PHILADELPHIA ELECTRIC COMPANY

Subject: Limerick Generating Station, Units 1 and 2
Request for Additional Information
Limerick SPDS Review

Reference: Letter, A. Schwencer to E. G. Bauer, Jr. dated
May 31, 1984

FIGURE ④: RPV CONTROL DISPLAY

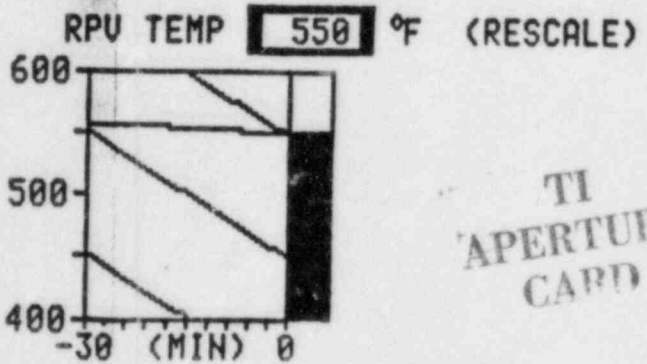
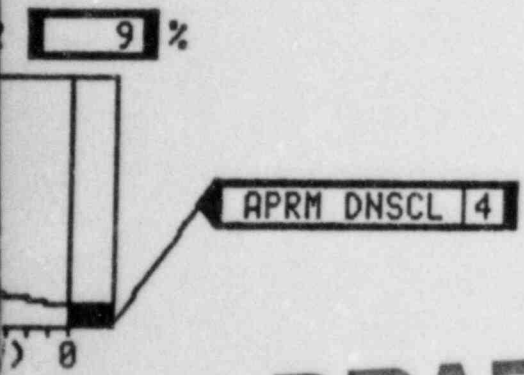
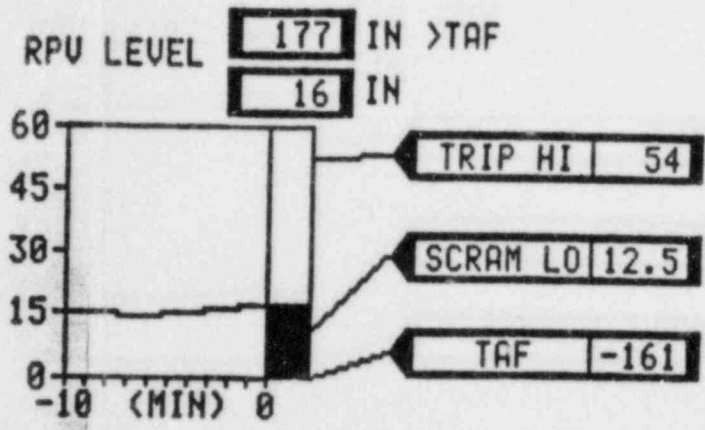
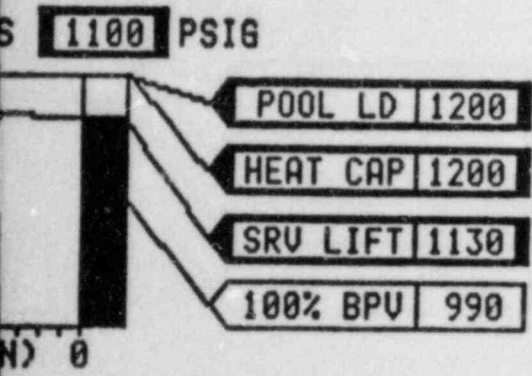
Reactor Pressure Vessel (RPV) pressure is an entry condition for the BWR Emergency Procedure Guidelines. This parameter should be included in your SPDS under Reactor Pressure Vessel Control. If this process variable is not included in the final SPDS design, provide a justification for not including it.

RPV pressure is included in the
RPV control display (Figure 620.02-1).
